EAST VILLAGE
Preliminary Development Plan Phase 2
Lots 14-22 & Tracts C, E-G
Section 8, Township 47 North, Range 31 West
LEE'S SUMMIT, JACKSON COUNTY, MISSOURI

Preliminary Development Plan

REVISIONS
REV. 11/10/2025
REV. 11/24/2025

SITE PLAN PHASE 2

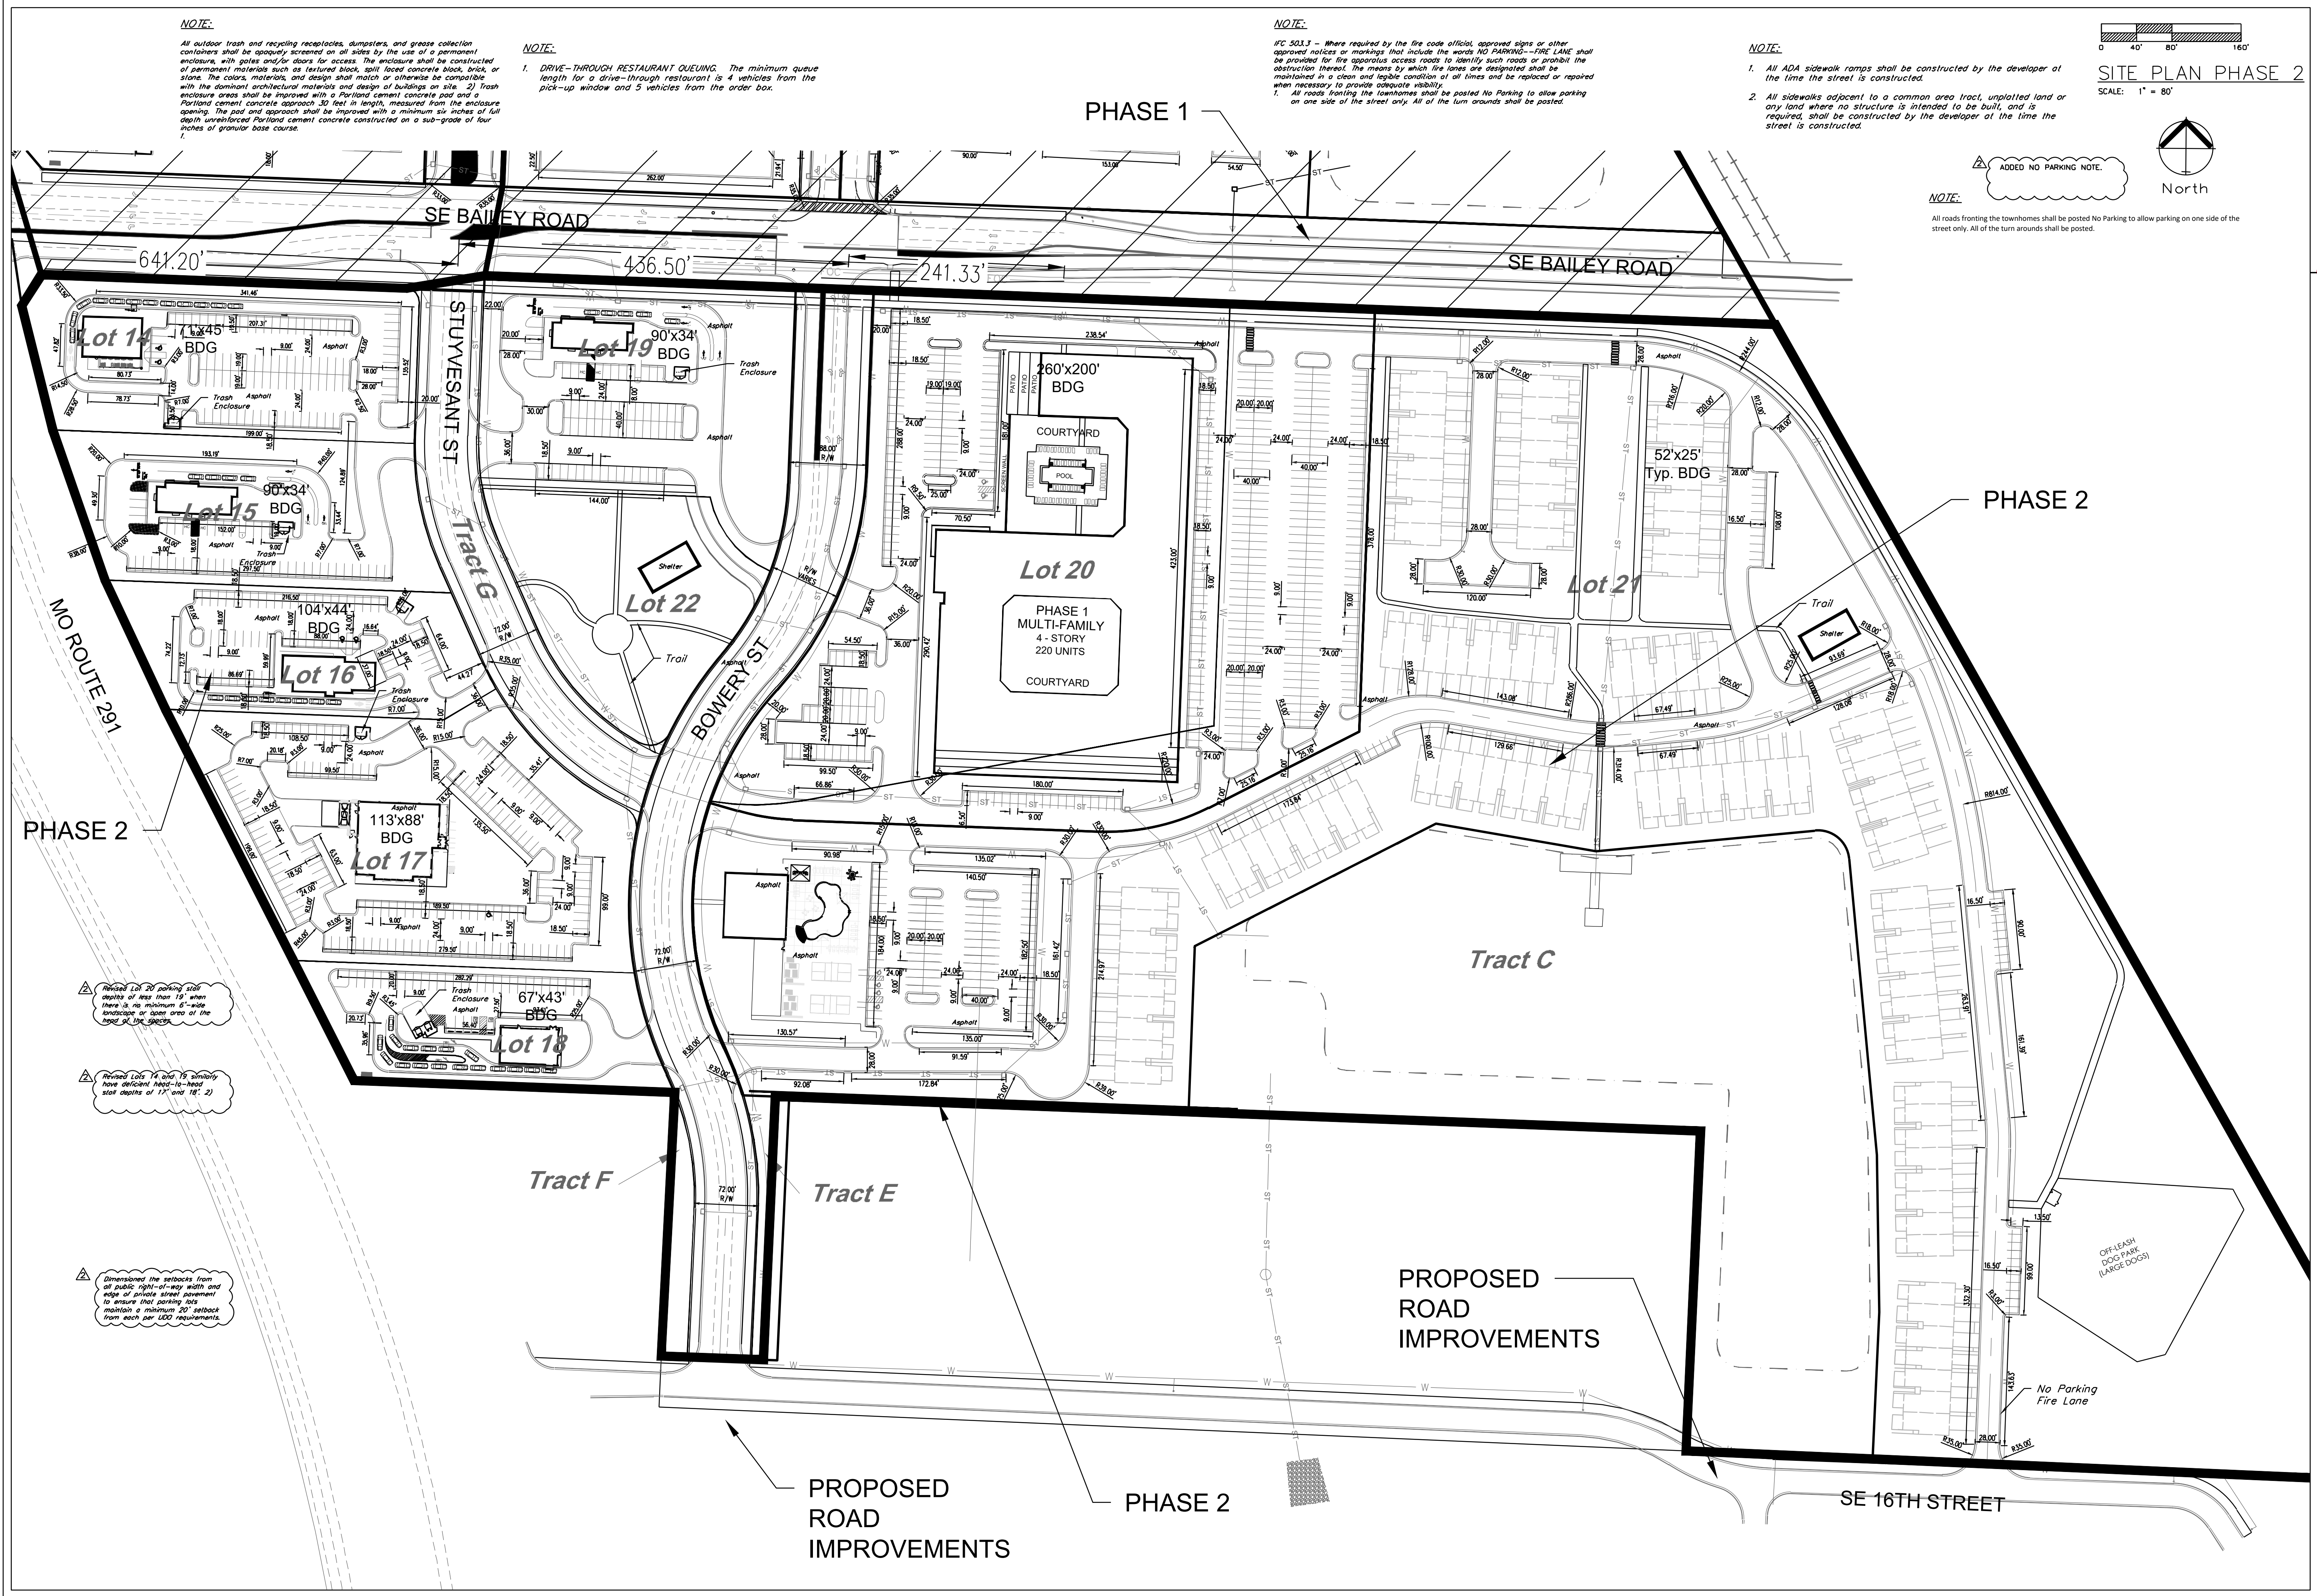
Revised Lot 20 parking stall depths of less than 12' when there is no minimum 6'-wide landscape or open area at the head of the street.

Revised Lots 14 and 16 similarly have deficient head-to-head stall depths of 17' and 16', 2).

Dimensioned the setbacks from all public right-of-way width and edge of private street pavement to ensure that parking lots maintain a minimum 20' setback from each per L&D requirements.

FIRE HYDRANT PLAN PHASE 2

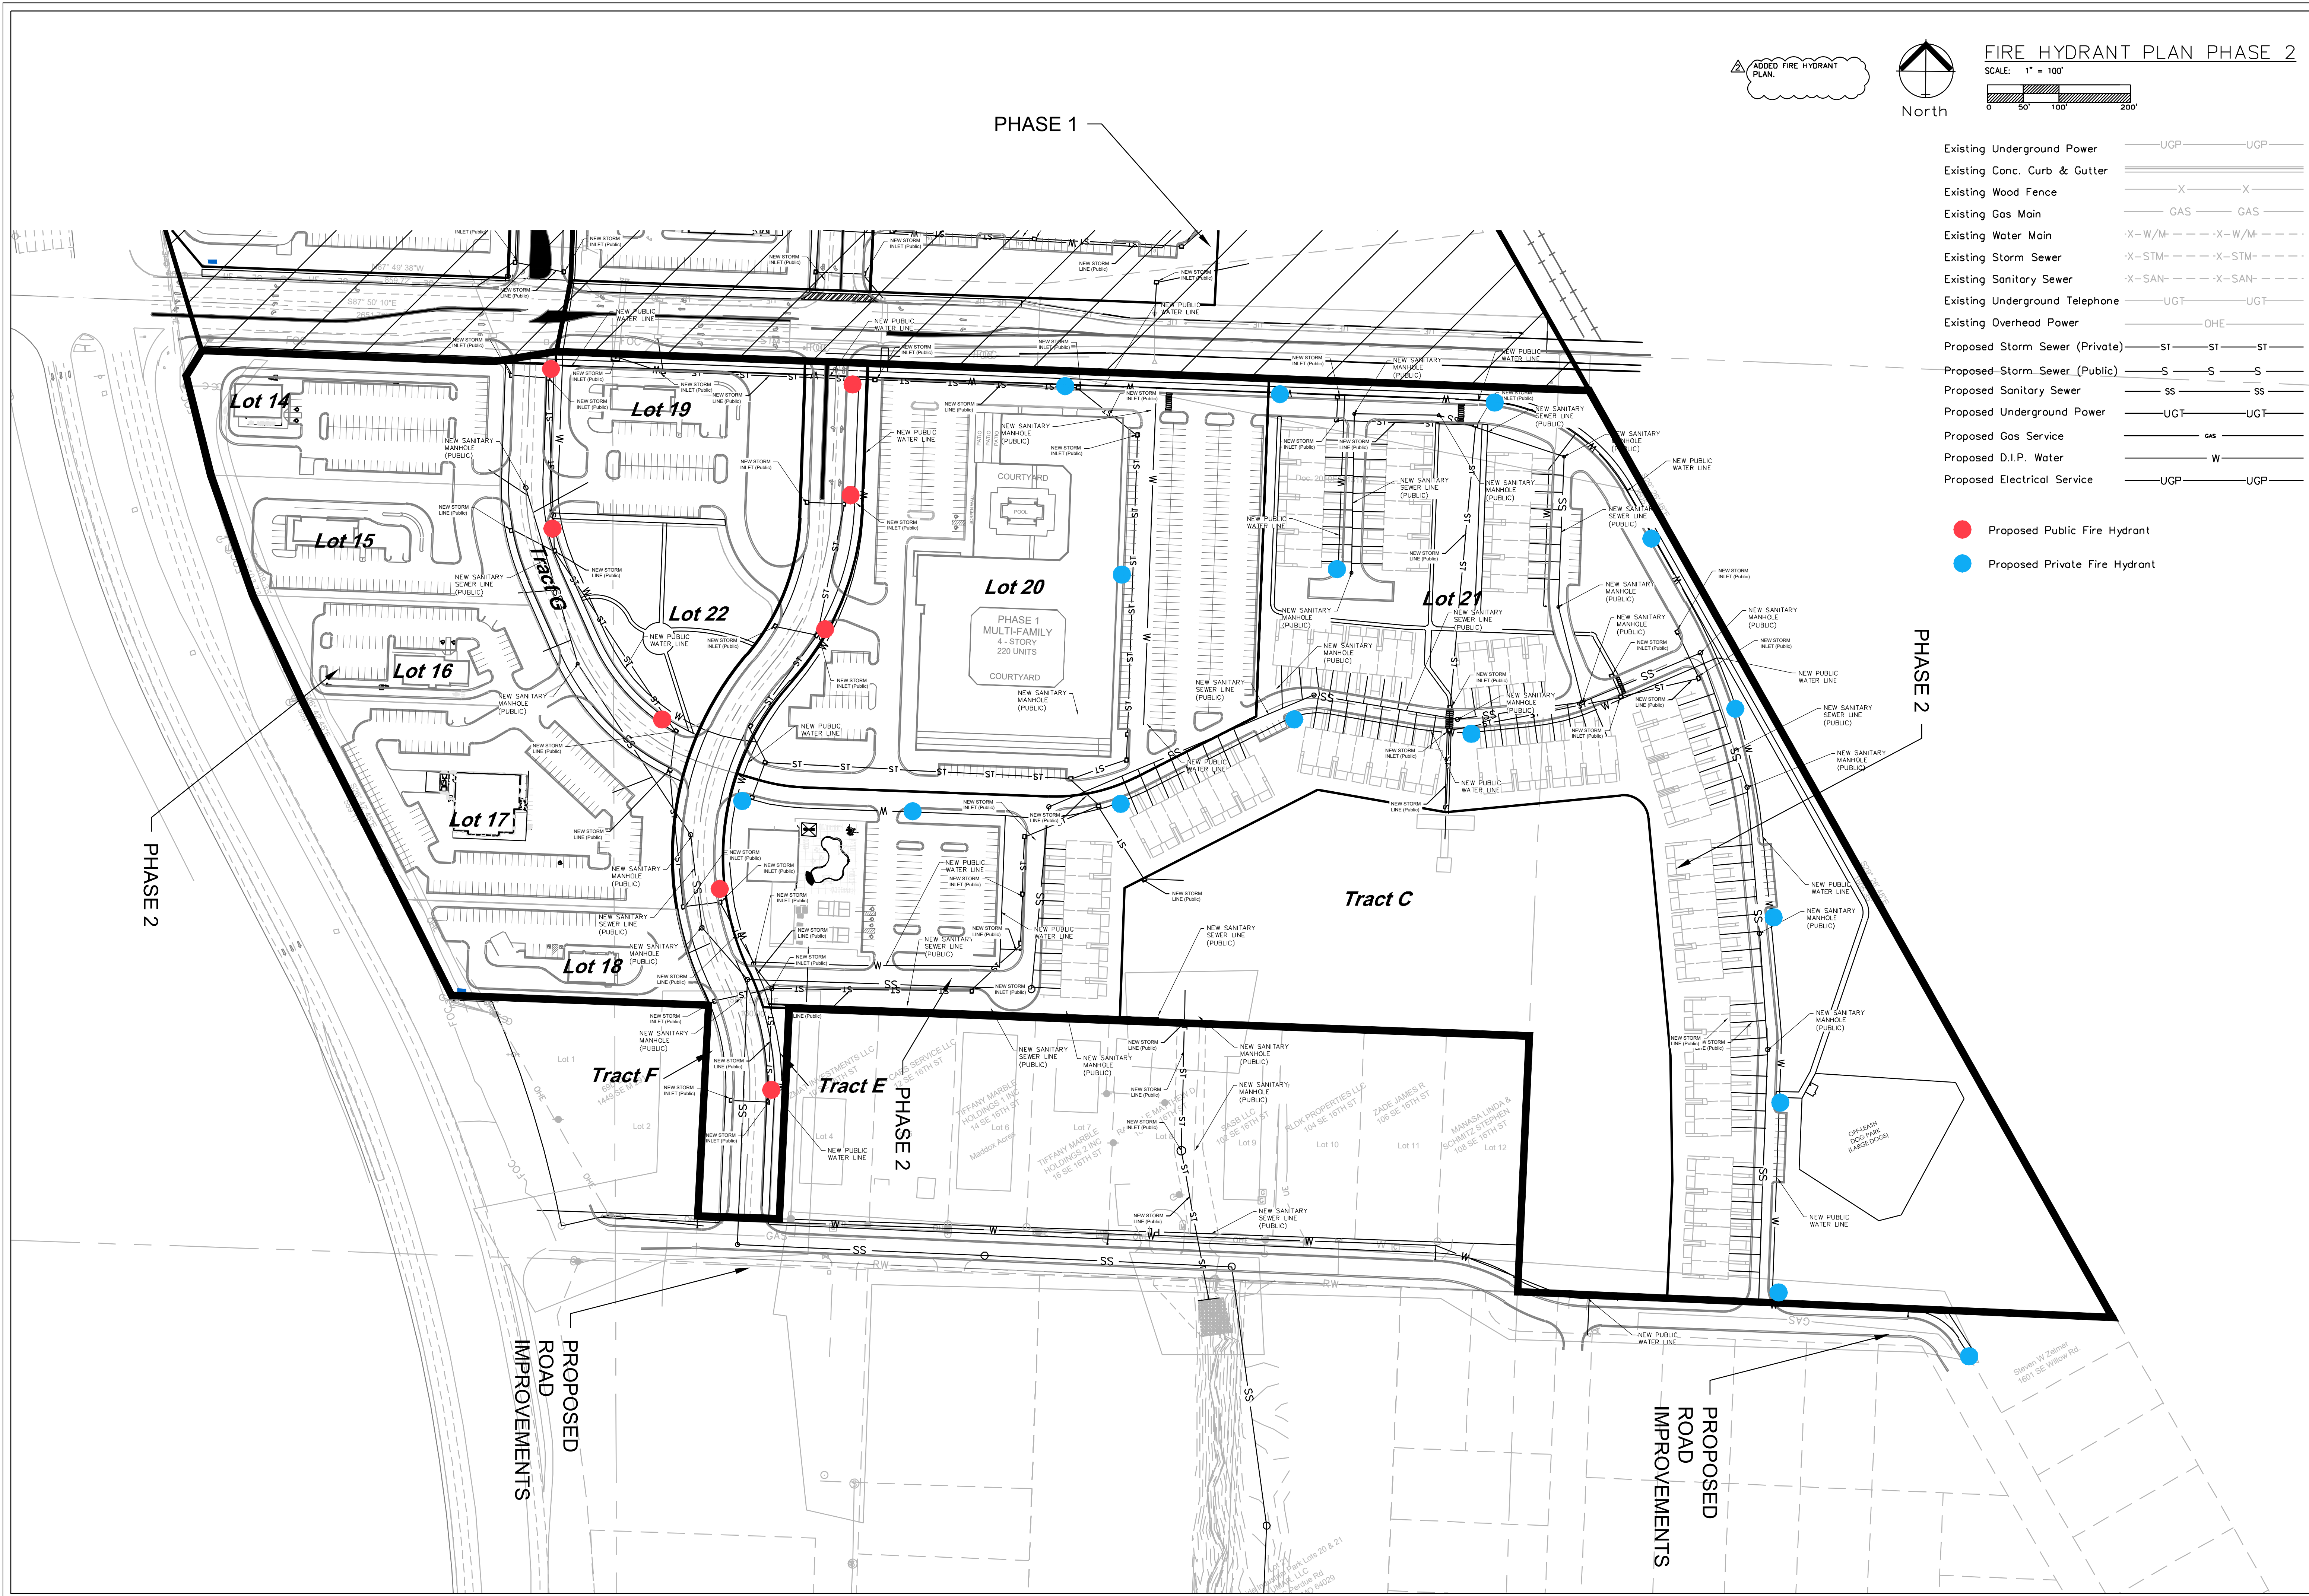
ADDED FIRE HYDRANT PLAN
